City of Red Bank
Board of Zoning Appeals

MEMORANDUM

Subject: Variance requests for 2101 and 2109 Dayton Blvd

Excerpt from Landscaping Plan (Full Plan attached):

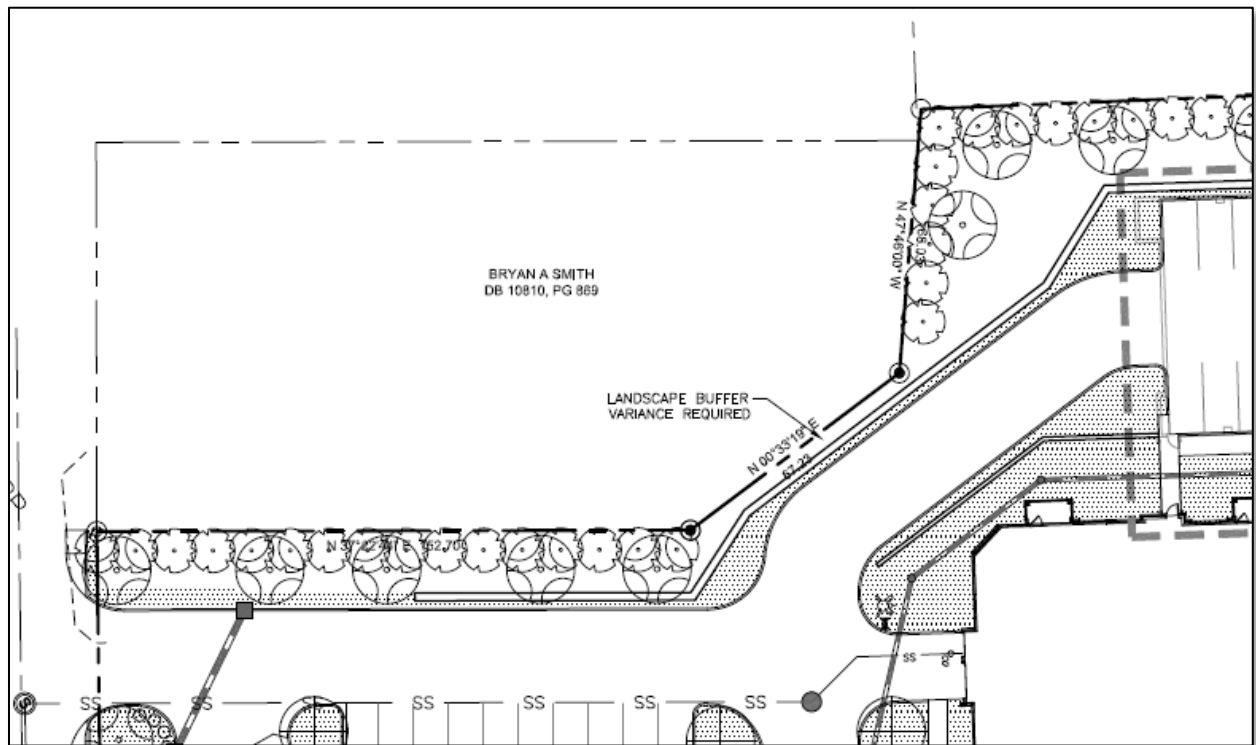
The applicant provides this type of screening as required, except for a 67-foot portion along the northwest boundary. This accommodates a driveway providing access to the proposed parking garage.

Excerpt from Conception Site Plan (full plan attached)

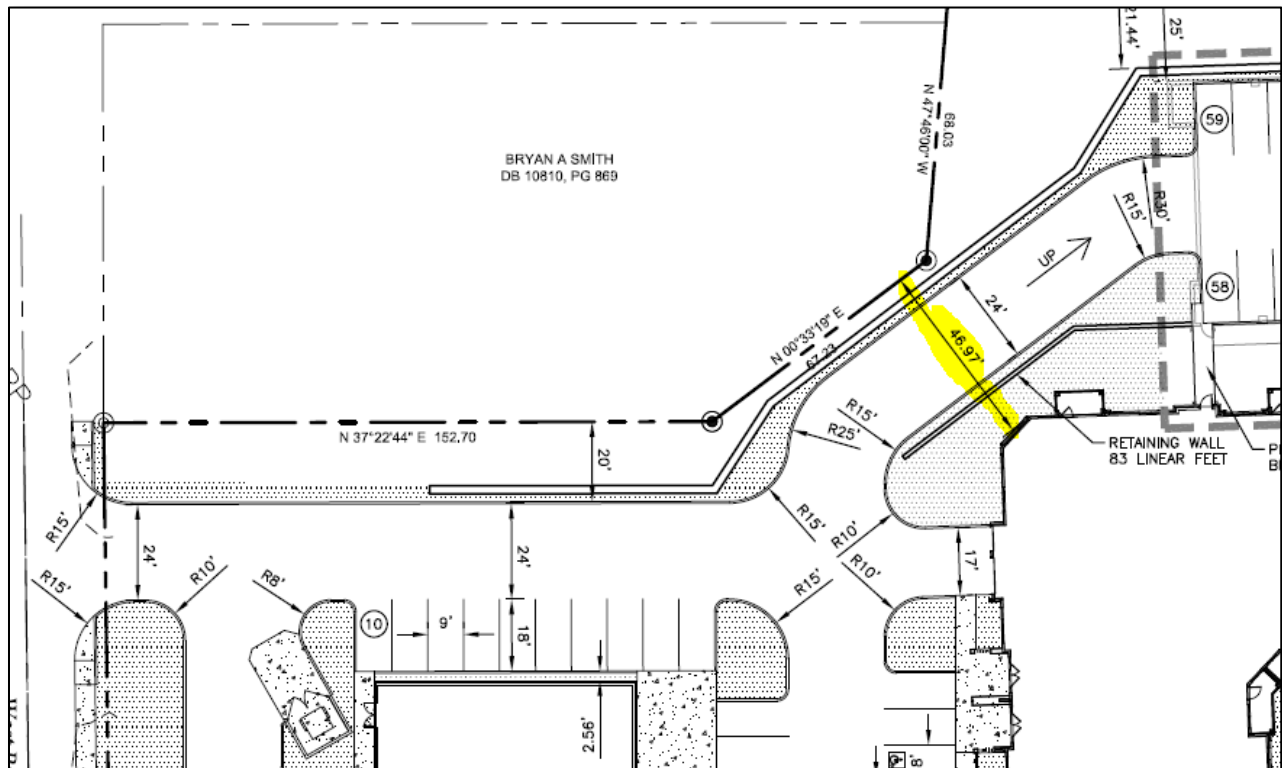
At the same portion of the site, a variance is requested to reduce the rear setback. The C-1 Commercial zone states that "No building shall exceed in height the shortest distance from such building to the nearest boundary of a residential zone." The applicant has proposed a 50-foot tall structure, which will be 49.97 feet from the nearest residential zone.
